CITY OF MOUNT DORA

**DATE:** July 29, 2026

**TO:** Development Review Committee

**RE:** **Request for Final Plan; Juniper Multifamily Townhomes** (Project Name); East of U.S. Highway 441 and south of Natoma Boulevard (Location); Brooks Stickler, Kimley-Horn & Associates (Applicant, Engineer); Owais Khanani, Elevation Mt. Dora, LLC (Property Owner); David W. Maxwell, Geopoint Surveying, Inc. (Surveyor); Project No. PR22-14FNLC.

**DETAIL 1:**

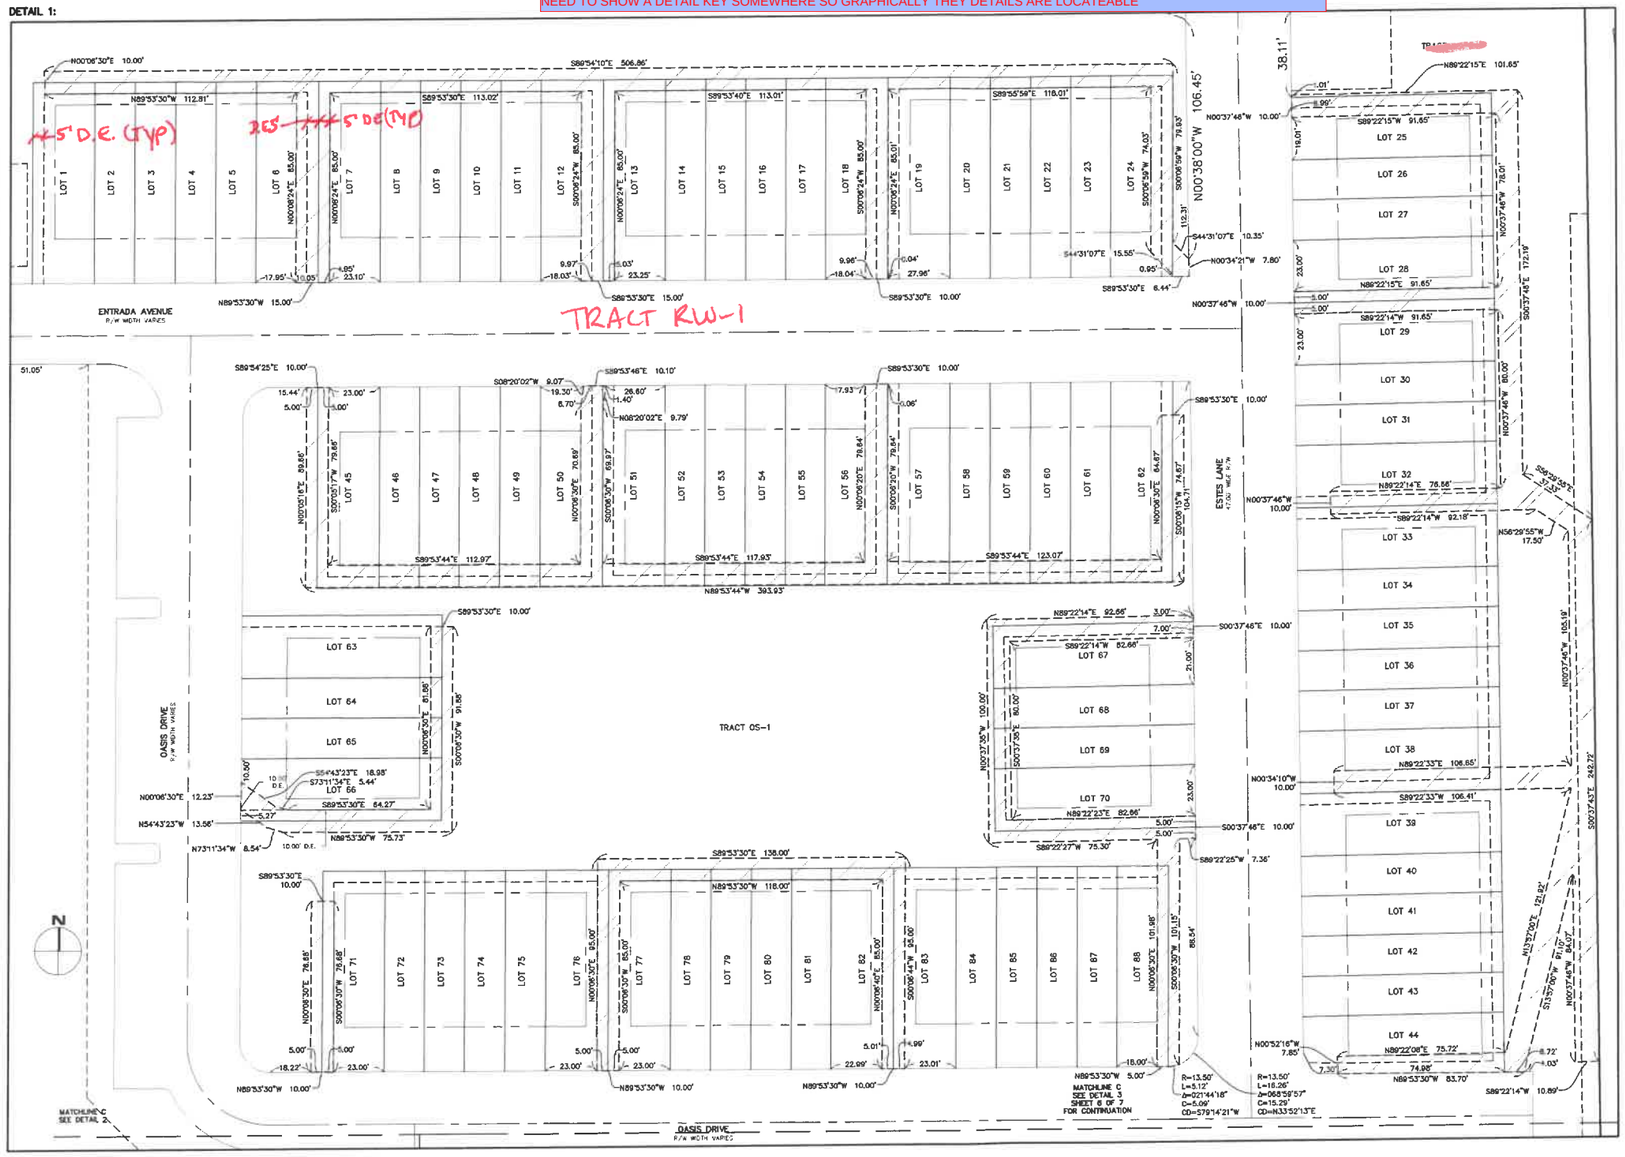
**Sheet 5:**

3. **Repeat Comment: Add dimension on Plat -** The drainage easement between Lots 6 and 7 is shown as 15' on the plans, Sheet C4.1. A 15' minimum easement should be provided as a storm pipe is running between the lots.
4. **Repeat Comment -** Call out the width of the drainage easement along the south side of Lot 66.
5. **Repeat Comment -** At Lot 66 – the drainage easement crosses a portion of the lot. Call out the width of the easement. This is typical of the easements around the other lots, all pages.
6. Resolved
7. **Repeat Comment -** The drainage easement south of Lot 120 is called out as 10.20' on the west end and 8.10' on the east end. The plans call this out as a 10' wide drainage easement. These widths need to match.
